DAQE-0103-93

Re: Modified Approval Order for Aircraft Purge System Near Building 287
Davis County CDS Al

Re: Distillation Units for the Aircraft Purge System

Re: 15 Jan 91 A.O. for Aircraft Purge System Near Bldg 287
(BAQE-021-91); 4 Jun 92 Ltr, Twelve Month Extension of
Variance for Aircraft Purge System (DAQC-670-92)

1 Atch
Distillation Units
Schematic

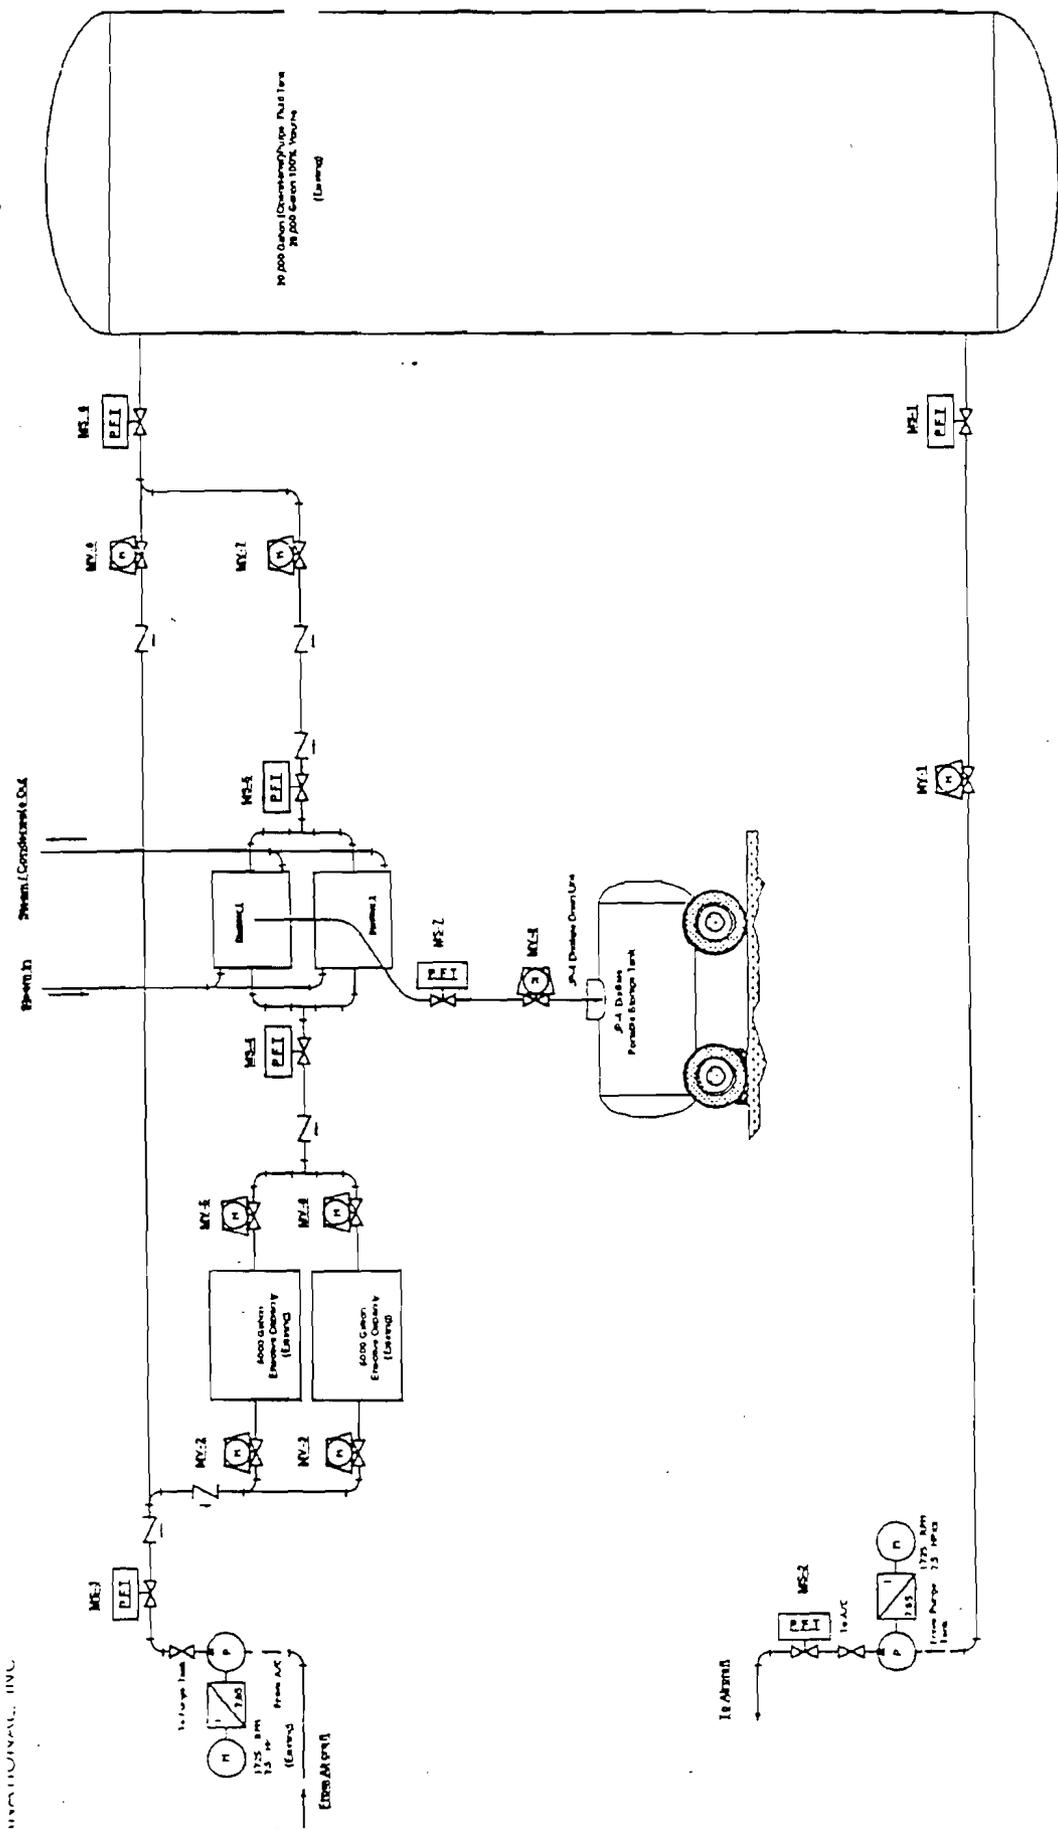
In lieu of catalytic incinerators, we propose to install distillation units operating under a vacuum. A schematic of distillation units is Attachment 1. Distillation units will separate and recycle the two product streams, namely, JP-4 and the purge oil. Since the distillation units will be closed loop, they will not be a source of air pollution and we feel a NOI is not required for these units. Fugitive emissions from piping valve flanges are negligible and estimated as follows:

We request you modify our 15 Jan 91 Approval Order deleting any reference to catalytic incinerators and include distillation units in the same.

This Modified Approval Order revises and replaces Modified Approval Order BAQE-021-91 dated January 15, 1991, by replacing two catalytic incinerators, used to control hydrocarbon emissions from the Aircraft Purge Facility near Bldg 287, with a closed loop distillation unit. The Aircraft Purge Facility is a facility used to purge the fuel from aircraft fuel cells thus eliminating the danger of explosion during the repair of an aircraft fuel cell. This Air Quality Modified Approval Order authorizes the project with the following conditions and failure to comply with any of the conditions may constitute a violation of this order:

1. Hill Air Force Base shall install a 28,000 gallon purge oil reclamation unit, which shall operate in conjunction with the two existing 6,000 gallon units. The unit shall be located at area 15090 near Building 287. The purge oil unit shall be installed according to the information submitted in the notice of intent dated August 1, 1988, October 8, 1992, and additional information submitted December 3, 1992.
